Title
Existing Plans

Drawing Number
23/023/02

Project Title Building Extension and Alterations
to 20 the Crossings Airmym, Goole. DN14 8LE
For Mr Collins

Ground Floor Plan

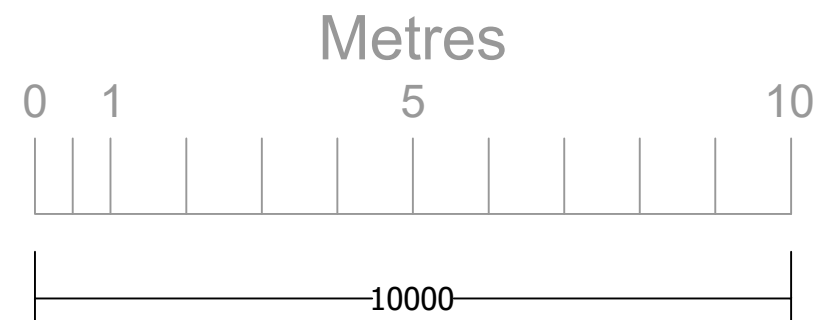
Rev B
Marked up to Planning Dept comments
